APPEAL SUMMARY

Status: Decision Rendered - Reconsideration of ID 22037

Appeal ID: 22166	Project Address: 622 NE 61st PI
Hearing Date: 11/20/19	Appellant Name: Robert Hawthorne
Case No.: P-003	Appellant Phone: 5033890754
Appeal Type: Plumbing	Plans Examiner/Inspector: Shawn Zangerle, Jim Bechtel, McKenzie James, Joe Blanco
Project Type: residential	Stories: 3 Occupancy: R-3 Construction Type: V-B
Building/Business Name:	Fire Sprinklers: No
Appeal Involves: Erection of a new structure, Reconsideration of appeal	LUR or Permit Application No.: 19-103949-RS
Plan Submitted Option: pdf [File 1] [File 2]	Proposed use: Residential Townhouse

1 MAXI-FILTRA INSTALLATION DETAIL

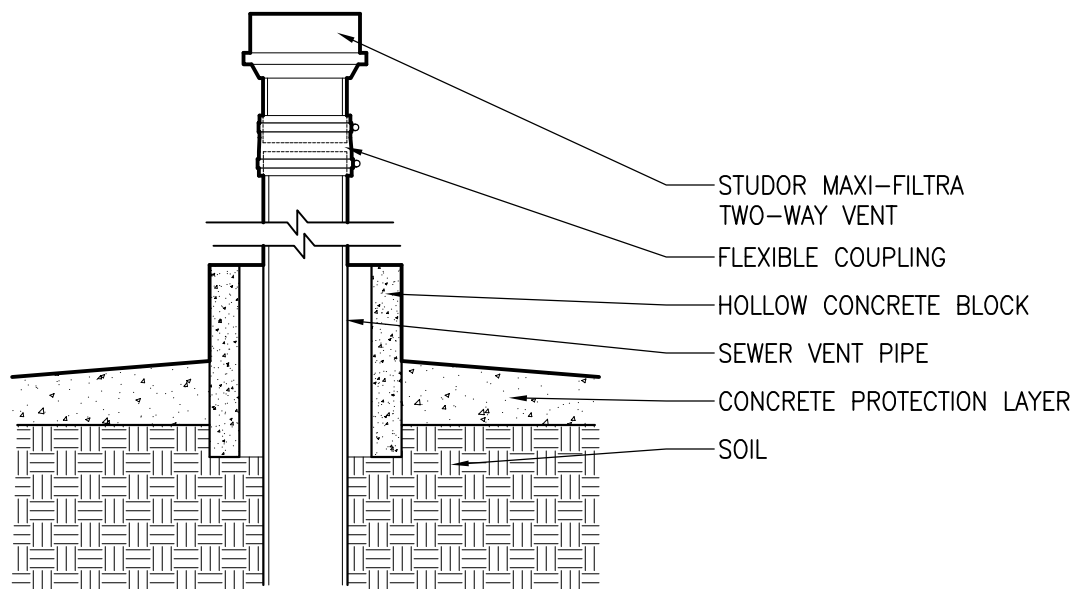
Concern: The Maxi-Filtra can be easily removed.

Response: The push fitting connection is proposed to be replaced with a flexible coupling (which is a Studor-approved installation method), which will render removal more difficult. In addition, we propose installing a hollow concrete block set in concrete over the pipe where it passes through the ground so that it cannot easily be cut off. A proposed installation diagram is attached.

Use of air admittance valve in lieu of roof vent: Granted provided valve is separate from the building cleanout.
